Notice of Modification

The project approval (MP 10_0046) granted by the Planning Assessment Commission, as delegate for the Minister for Planning, for the NRE No. 1 Colliery Preliminary Works Project on 13 October 2011.

APPENDIX 2: PROJECT LAYOUT PLAN

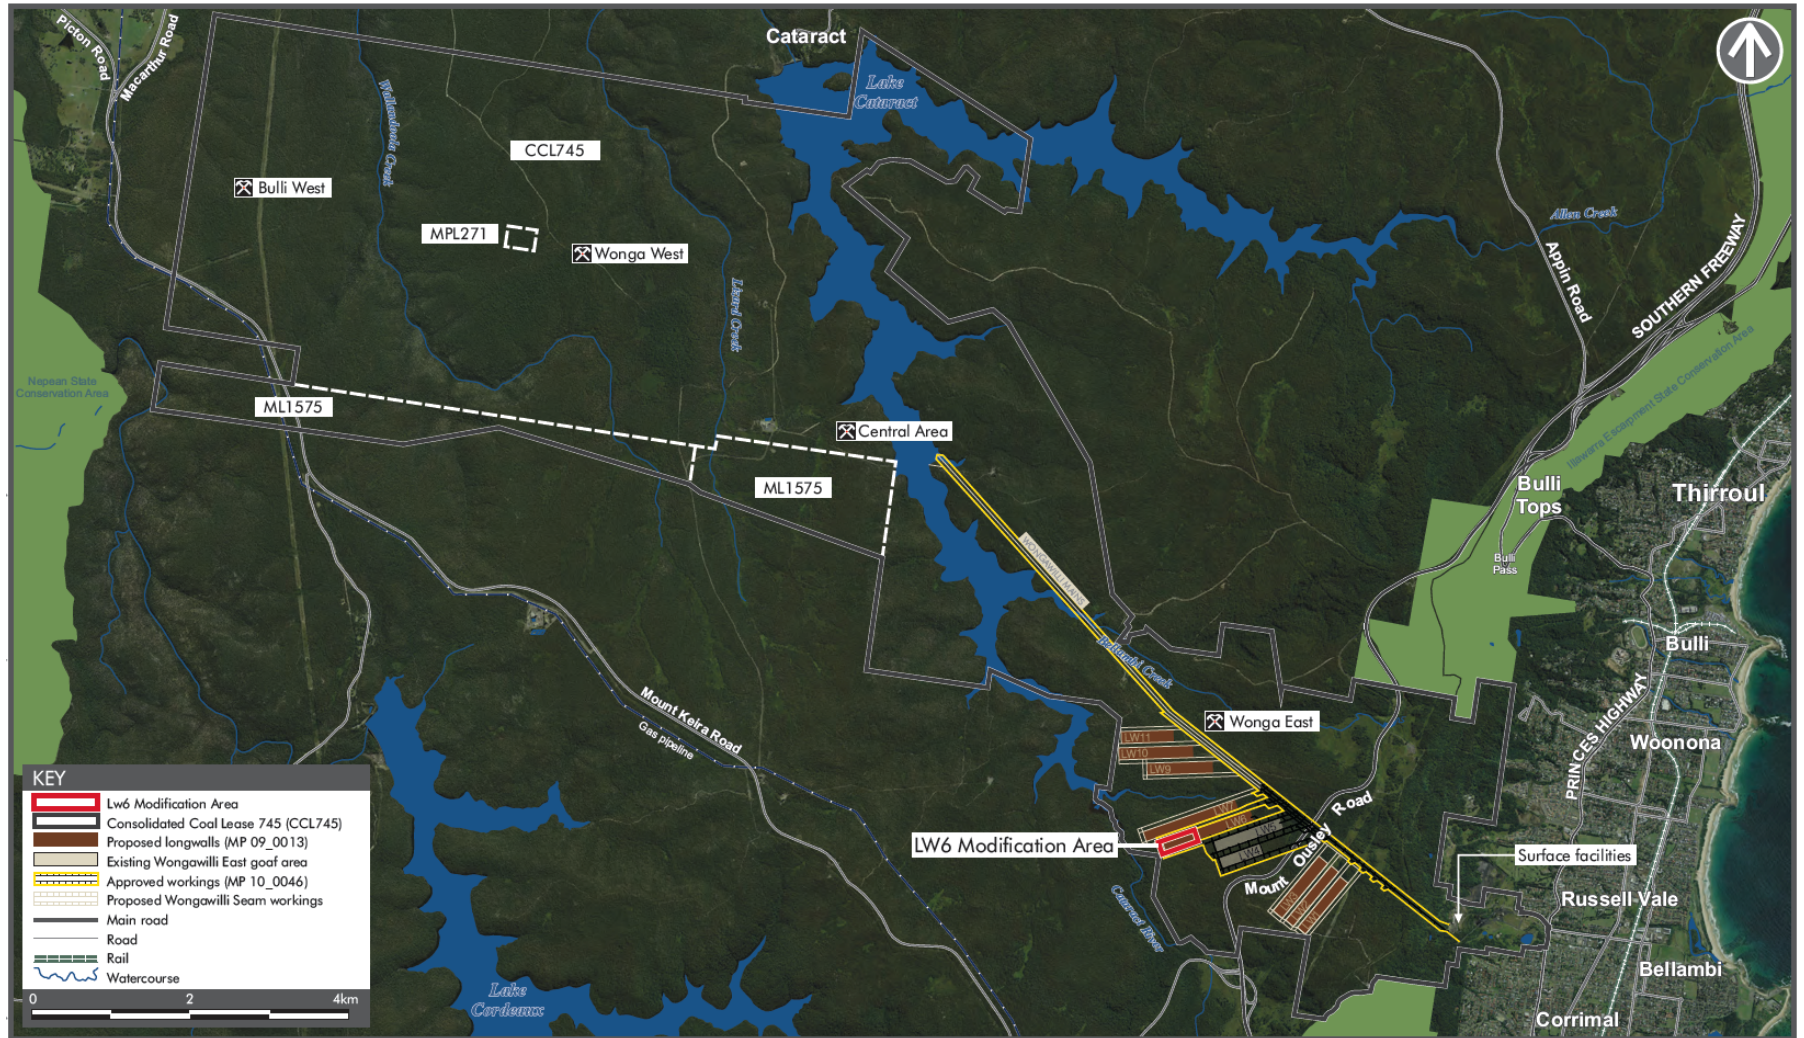
- 37A. Prior to the commencement of mining in Longwall 6, the Proponent shall establish a groundwater bore between Longwall 6 and the Cataract Reservoir that investigates and monitors the height of groundwater depressurisation in this area, to the satisfaction of the Secretary.
26. Delete Appendix 2 and replace with:

Figure 2

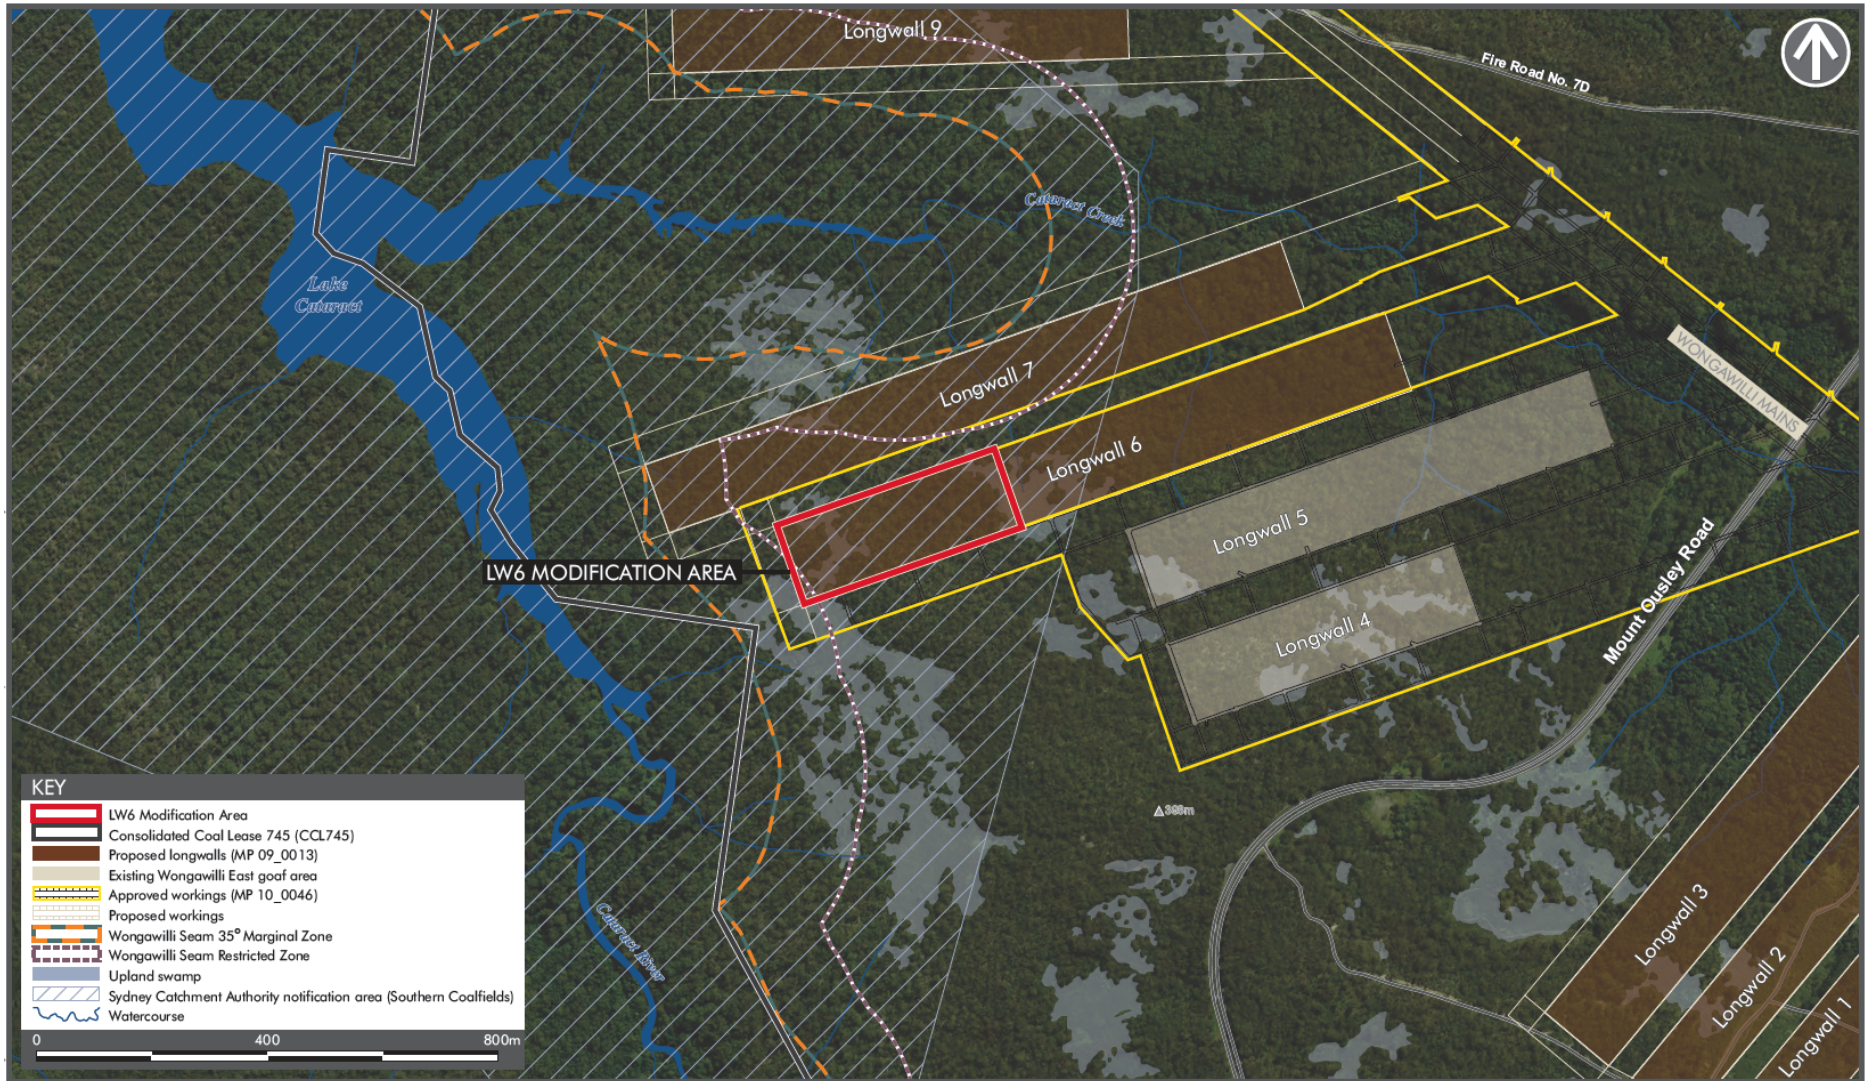
5A. The Proponent shall not extract more than the first 365 metres of Longwall 6.

Note: This limit on the extraction of Longwall 6 aligns with the number 10 cut-through in Maingate 6, which is shown in Figure 2 of Appendix 2.
